Technical Evaluation Report

Draft Waste Incidental to Reprocessing
Evaluation for Closure of
Waste Management Area C,
Hanford Site, Washington

Final Report

U.S. Nuclear Regulatory Commission
Office of Nuclear Material Safety and Safeguards
Washington, DC 20555-0001

Figure 3-26 Planar Rectangular Window Containing Six Model Cells for Which the Weighted Average Hydraulic Conductivity was Calculated
 [Figure C-5 in RPP-RPT-58949 (2016)]

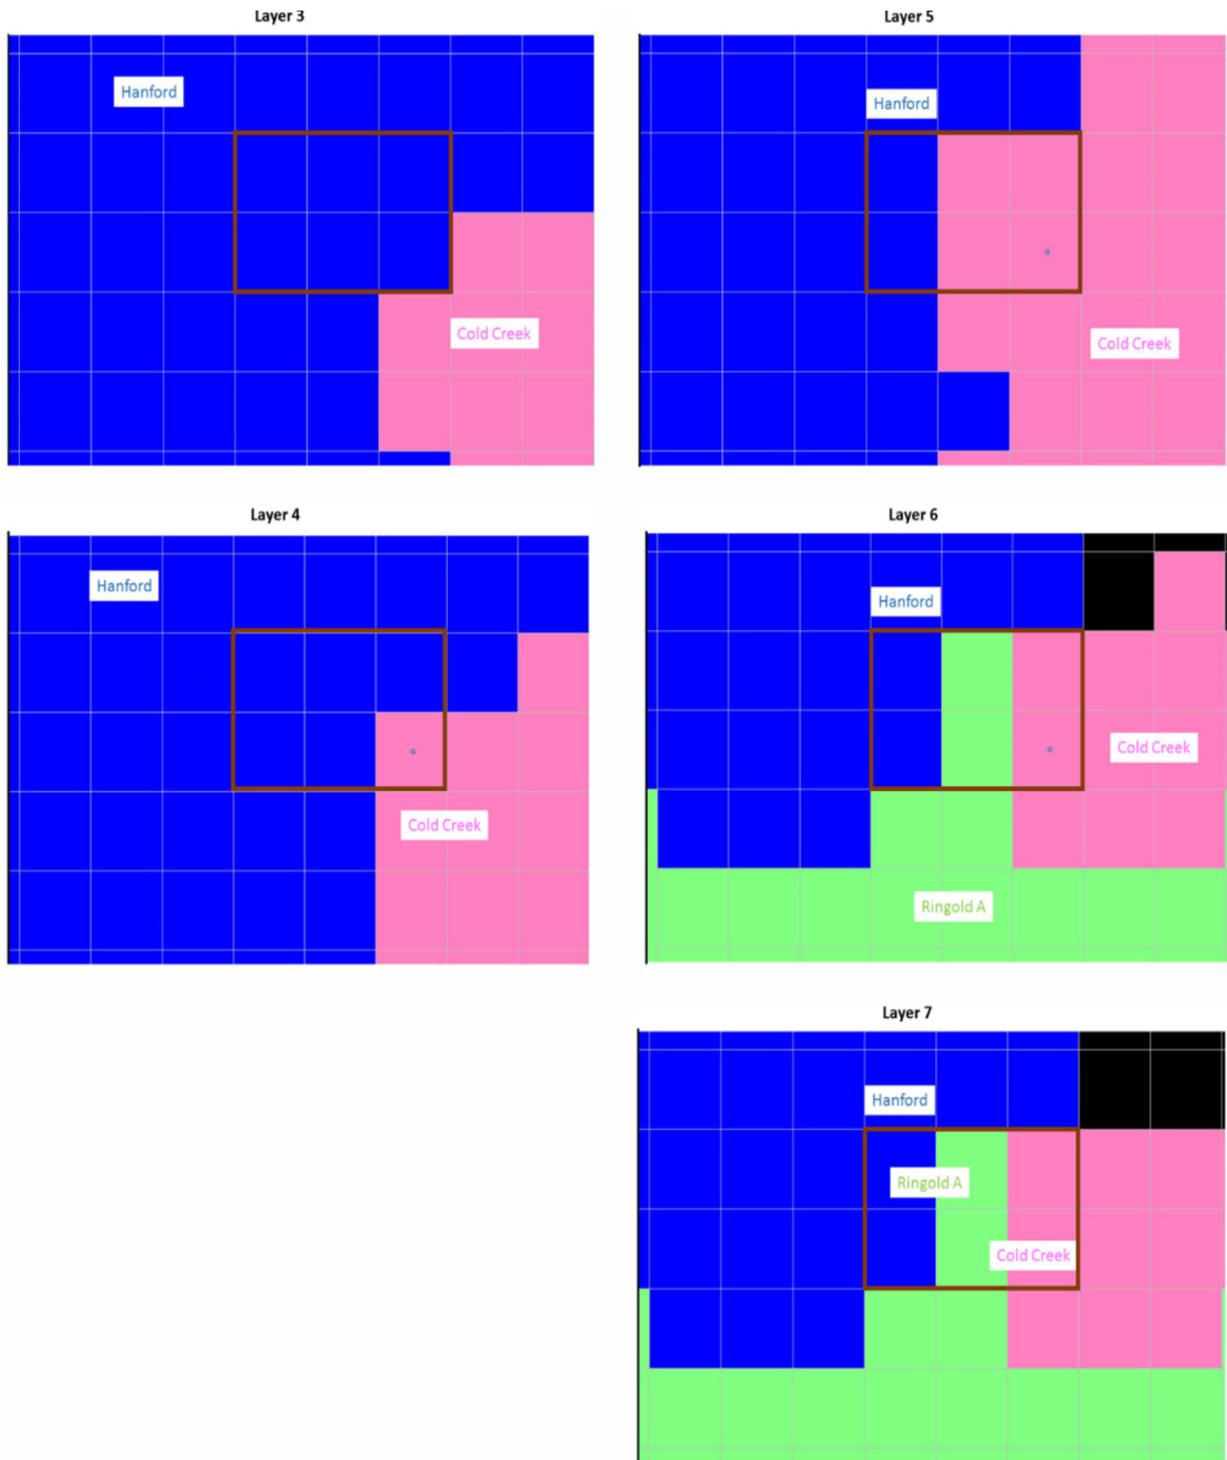
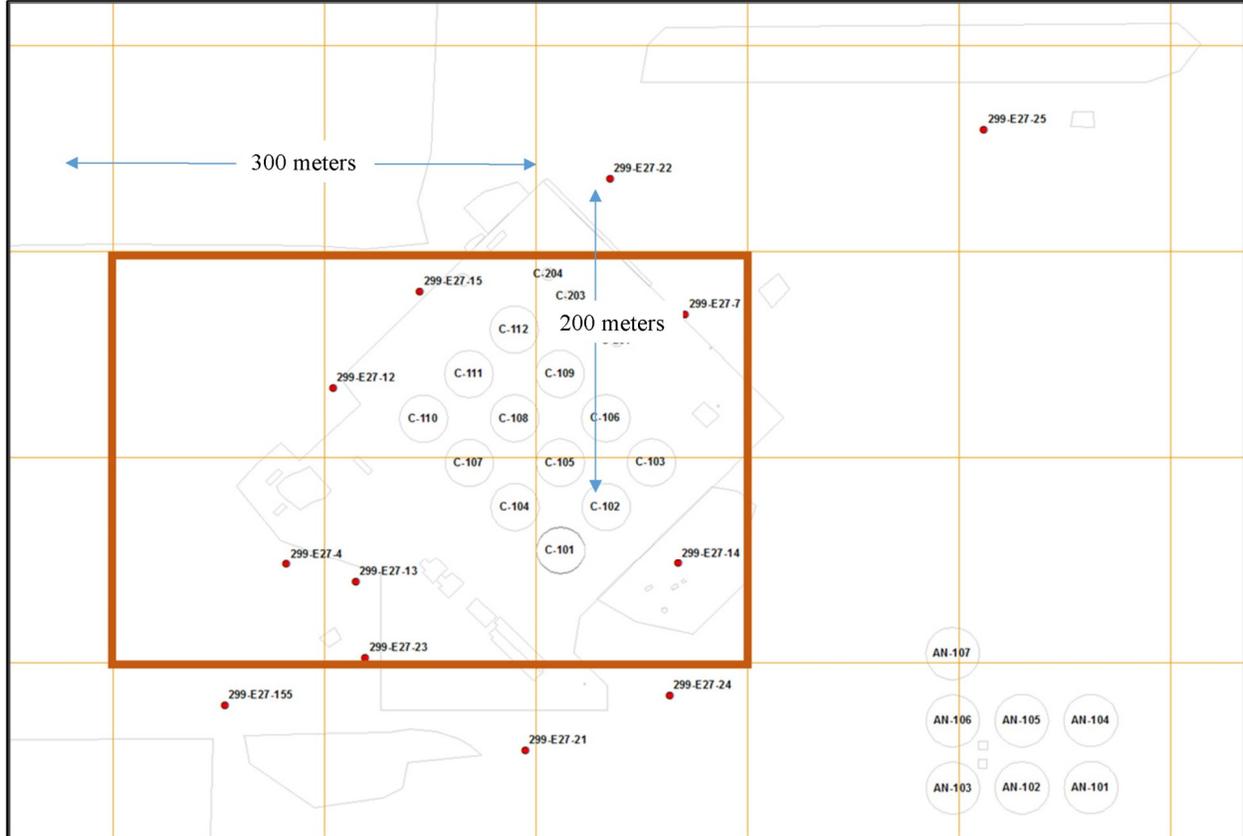
Most of the flow and transport properties used in the WMA C PA by DOE, including the hydraulic gradient, were obtained from results developed from the calibrated CPGWM (CP-47631, 2015). The planar rectangular window, as shown Figures 3-25 and 3-26, contains six model cells. This rectangular window was used by DOE to calculate the hydraulic conductivity value of the STOMP WMA C saturated model layer. The C-Tank Farm with single-shell tanks is visible in the background of Figure 3-25. Much of the WMA C is encompassed within the rectangular window as is an area to the east of WMA C. The area is equivalent to two CPGW model cells. However, this additional area to the east is not representative of the flowpath used by DOE to model contaminant concentrations. This flowpath is 100 m (328 ft) downgradient from the fenceline at the POC. An alternate approach that would encompass this flowpath would be to move the planar rectangular window containing the six model cells to the east to

encompass this critical flowpath while still including WMA C (see Figure 3-26). Moving the window to the east would, however, change the representation of the hydrogeological units within that window (see Figure 3-25) based on the hydrogeologic framework of the CPGW model. The Cold Creek unit would be represented by a greater number of model cells while the Hanford units would be less represented. This would change the values used to obtain the effective hydraulic conductivity for the aquifer within the WMA C STOMP model. Using this averaging approach and following the same procedure are described in Section 3.7.1, the rounded calculated layer-thickness-weighted hydraulic conductivity obtained would be 5700 m/d (18,700 ft/d), roughly half the value shown in Table 3-13 (i.e., 11,000 m/d). As concentrations in the water well change approximately linear with the hydraulic conductivity in this model, this would result in approximately doubling the dose.

Figure 3-27 Field-scale Dispersivity in the Saturated Zone as a Function of Scale
 [Gelhar et al., 1992]

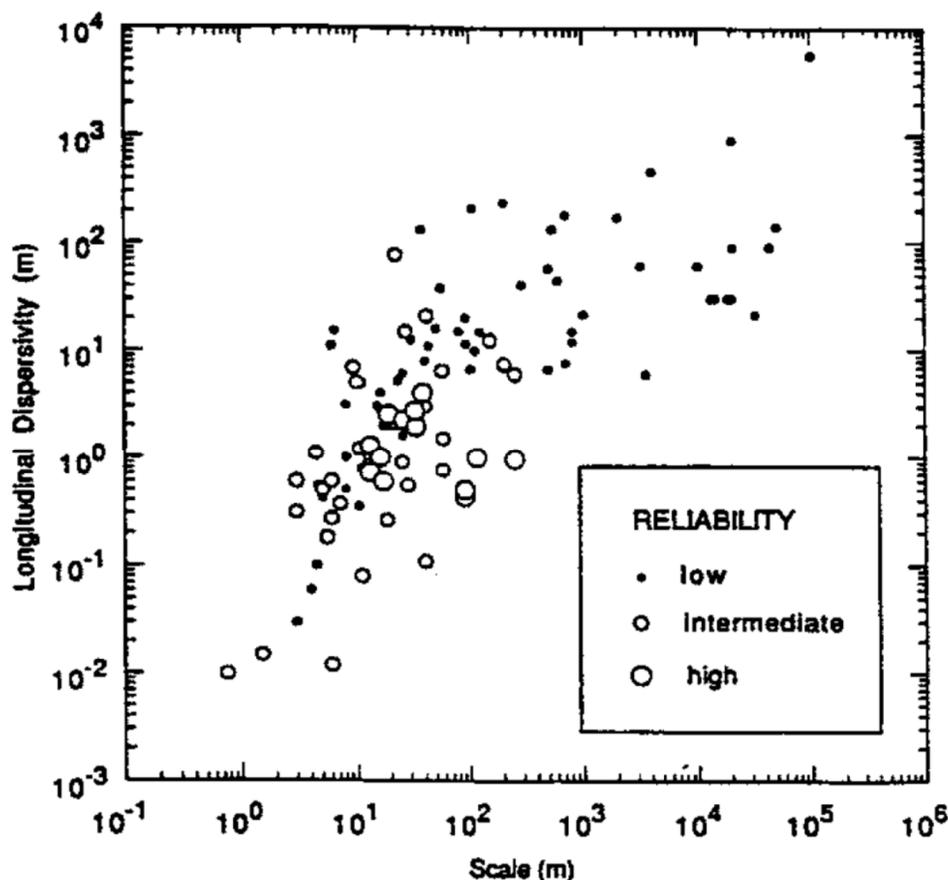
Field-scale dispersivity was rated relatively high in the results of the uncertainty analysis, as seen in Table 8-13 in the WMA C PA. The range in saturated zone dispersivity at the scale of the WMA C model is estimated by DOE to be from 1 m to 20 m (3.3 ft to 65.6 ft). However, as can be seen in the Figure 3-27, most data points with high reliability are 5 m (16 ft) or less, possibly indicating that 10.5 m (34.4 ft) is not a representative value of those values with high reliability. The range of dispersivity values used by DOE in the uncertainty analysis may be skewed towards the high end. The calculated values of the three general relationships for saturated longitudinal dispersivity are equal to 17 m, 6 m, and 3.5 m, or an average of 8.8 m or a median of 6 m. Since this parameter is ranked relatively high in importance at 1,000 years and 3,400 years after closure, the technical basis for the base case value of 10.5 m (34.4 ft) needs to be adequate or the range of values used in the uncertainty analysis needs to be sufficiently broad to account for the uncertainty. The base case value assigned by DOE lacks adequate technical and model support.

Figure 3-38 Combined Failure of Multiple Safety Functions

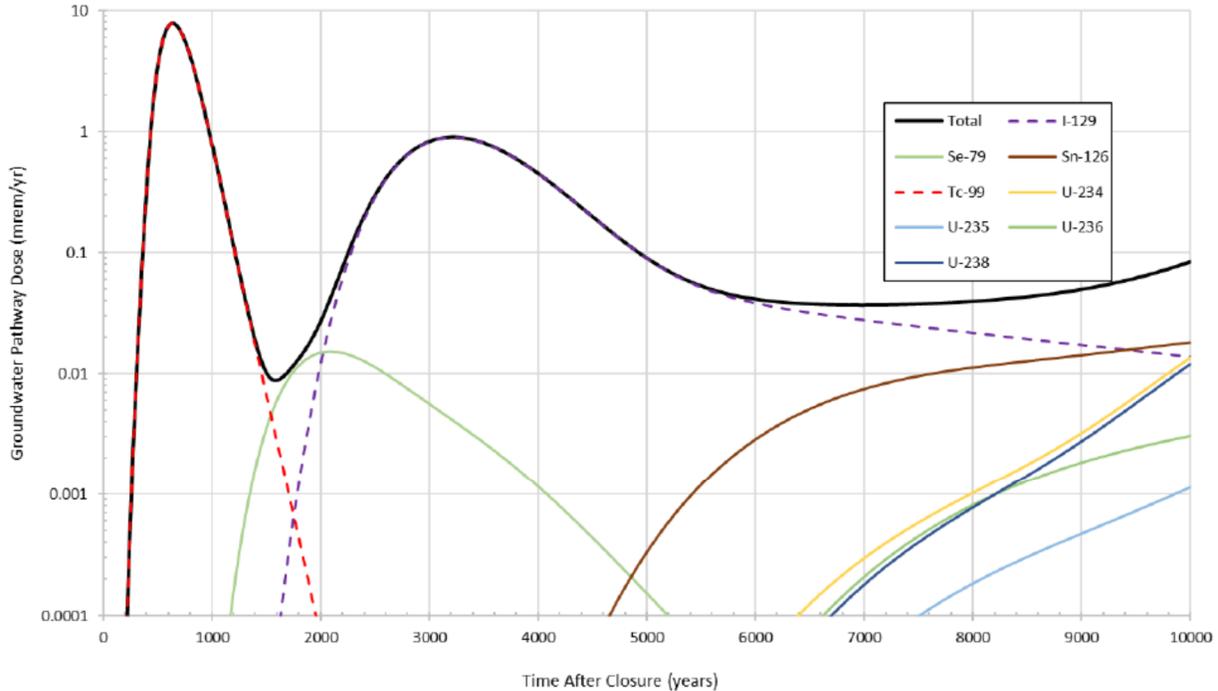
The results of the analysis are shown in Figure 3-38. The peak dose within the compliance period has increased to approximately 0.08 mSv/yr (8 mrem/yr) from 4×10^{-6} mSv/yr (4×10^{-4} mrem/yr) (a factor of 20,000 increase). NRC agrees that some aspects of the evaluation are pessimistic, but the analysis is useful to support regulatory decision-making. In a system model with numerous uncertainties that were not evaluated in the probabilistic system model analysis, the impact of those uncertainties cannot be determined with one-at-a-time evaluations; it is conceptually flawed to use one-at-a-time evaluations to evaluate the global impact of uncertainties. This approach should not be used in future waste evaluations (Recommendation #55). NRC's conclusions about the appropriateness of uncertain evaluations are based on the system model and the global uncertainty evaluation case evaluated in response to NRC's RAI. The safety function analyses are useful to evaluate and understand the role individual safety functions may have, but safety function analysis is most useful if it is done with a full or partial factorial analysis, as was done previously by the NRC (CNWRA, 2011).

Figure 4-1 Chronic Intruder Doses for the CR-Vault

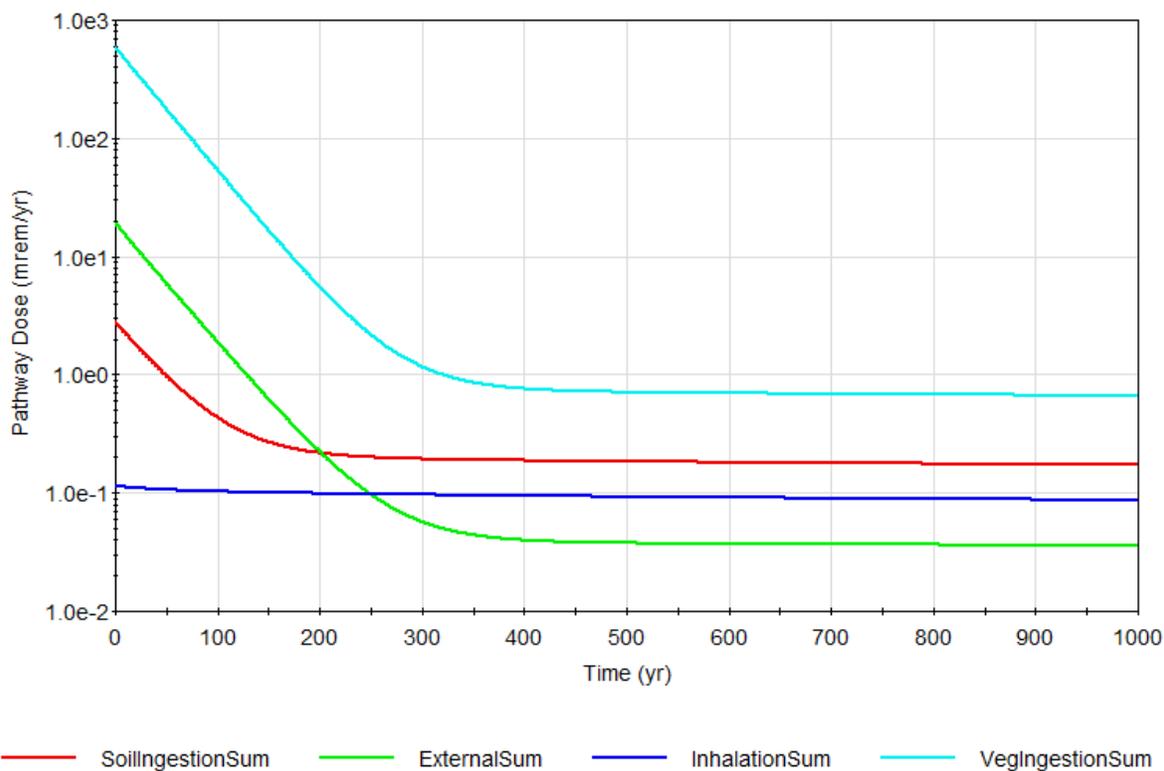
The NRC staff examined the dose results in DOE's PA model for the chronic intruder. Depending on the component and time period examined, the non-plant ingestion pathways accounted for a maximum of approximately 20-30% of the dose. The smaller dilution factor would only apply to this fraction of the dose contribution. When the extra factor of 4 is backed out and the extent of the plowing depth of 15 cm (0.49 ft) is adjusted to 1 cm (0.03 ft) for the non-plant ingestion pathways, the NRC staff calculated that the SOF for the chronic intruder would be 0.17 for the CR-011 tank compared to DOE's value of 0.18.

Essentially, the extra factor of 4 from double counting of the NRC dilution factor is offset by the assumption regarding cuttings mixing. Figure 4-1 is the intruder dose plot for the chronic intruder for the 244-CR vault. The doses drop off very rapidly with time from the decay of ^{90}Sr and ^{137}Cs . Doses during the first 100 years are not possible due to active institutional controls being in place.
